Re: Opposition to Addendum for the Coachella Valley Arena

(Specific Plan No. 343 Amendment No. 2; General Plan Amendment No. 200005; Change of Zone No. 2000025; Plot Plan No. 200021; Tentative Parcel

PLANNING COMMISSION AGENDA ITEM 4.3 (April 7, 2021)

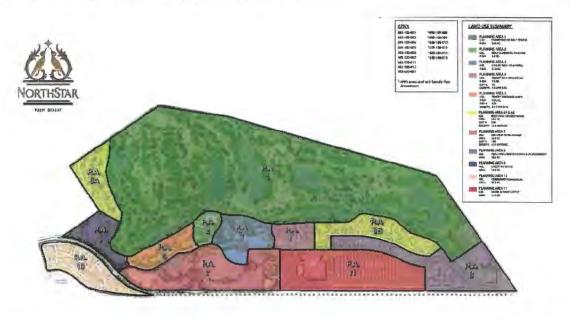
As shown below, the proposed amendment to the NorthStar SP add a new Planning Area 11 for the Arena and reduce the size of Planning Area 8 and make adjustments to the boundaries of Planning Area 4, 6, and 7 to accommodate the Arena.
